Addendum to the Big Otter River Basin Fecal Coliform TMDLs (January 2001)

EPA's comments, as provided in their letter reviewing the fecal coliform TMDLs for five impaired segments in the Big Otter River basin, are re-stated in italics and followed by the particular response for each comment.

Figure 1. Difference in fecal coliform concentration for the modeling run with five point sources and the modeling run with only the original two point sources used in the simulations.

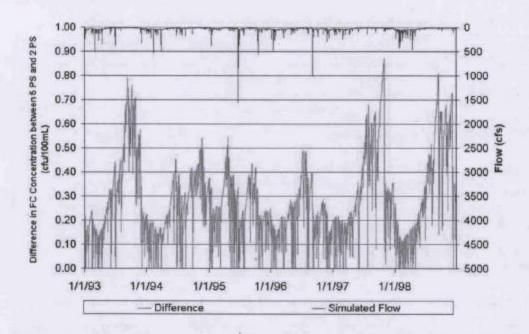
EPA: Section 7.2.1, States that there are four permitted point sources in the Little Otter River watershed. However, in Section 7.3.2 it mentions that there are five permitted point sources, two of which were modeled for. Please verify the number of permitted point sources within this watershed. Was the Waste Load Allocation (WLA) set at a value that incorporates the permitted discharge of all of the permitted point sources? How was the loading from the facilities not modeled incorporated into the WLA and how was it determined that this additional loading would not affect the model? A WLA for each point source should be provided as an addendum to the report. A modeling run showing the effects of the non-modeled point sources should be provided with the addendum.

Supporting this assessment is a modeling run using 200 cfu/100mL at design flow for all five point sources originally considered in the TMDL. Figure 1 shows a plot of the difference between the two modeling runs, indicating that the difference in terms of concentrations never exceeds 0.9 counts/100 mL. This increase did not result in any violations of the 30-day geometric mean standard with a 5% margin of safety, i.e. 190 cfu/100mL. Therefore, the Little Otter River TMDL accurately represents the point sources along this segment.
